DART AEROSPACE LTD		Work Order:	148466
Description: Bar		Part Number:	D3196-1
Inspection Dwg: D3196		Rev: C	Page 1 of 1

DESIGN	DRAWN BY	DART AEROSPACE LTD	REV. C
QQ	J.B.	HAWKESBURY, ONTARIO, CANADA	
CHECKED RH	APPROVED	DRAWING NO. D3196	SHEET 1 OF 3
DATE 06.10.31		TITLE BAR	SCALE 1:4
A	03.06.25	NEW ISSUE	
B	06.09.25	ADD D3196-5	
C	06.10.31	ADD SLOTS ON -1; REMOVED -5

DRAWING NO. D3196	TITLE BAR	REV. C	DART AEROSPACE LTD ENGINEERING ORDER		D.E.O. NO. D3196-C-1	SHEET NO. SHEET 1 OF 2	SCALE NTS
DRAWN <i>ASS</i>	CHECKED <i>[Signature]</i>	MFG. APPR. <i>[Signature]</i>	APPROVED <i>[Signature]</i>		DE APPR. <i>[Signature]</i>		
DATE 08.08.27	DATE 08.08.28	DATE 08.08.29	DATE 08.08.29	DATE 08.08.29	DATE 08.09.04

D3196-1 BAR

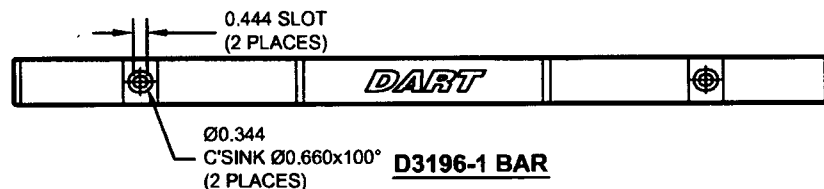
SHEET 1 MODIFY SLOT DIMENSIONING ON D3196-1 AS SHOWN:

IS:

WAS:

NOTE: THIS CHANGE HAS BEEN DONE TO CLARIFY SLOT DIMENSIONS ONLY. NO CHANGES HAVE BEEN MADE TO THE PARTS
SEE NCR 08-051 FOR FURTHER INFORMATION
ALL OTHER INFORMATION REMAINS UNCHANGED

D3196-3 BAR

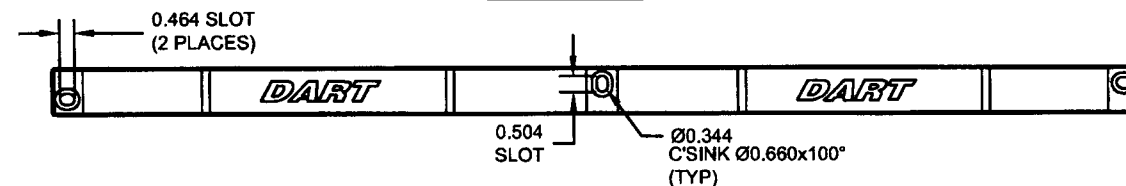
SHEET 2 MODIFY SLOT DIMENSIONING ON D3196-3 AS SHOWN:

IS:

WAS:

D3196-4 BAR

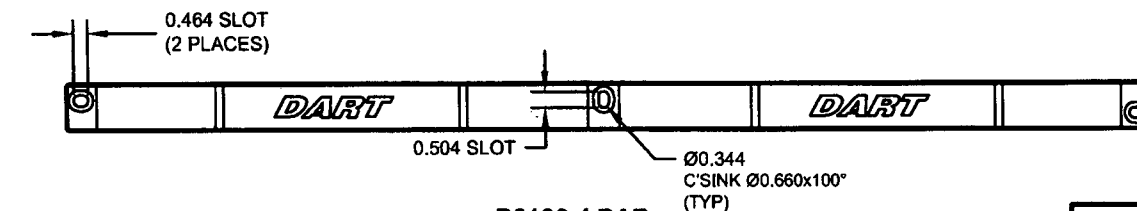
SHEET 3 MODIFY SLOT DIMENSIONING ON D3196-4 AS SHOWN:

IS:

WAS:
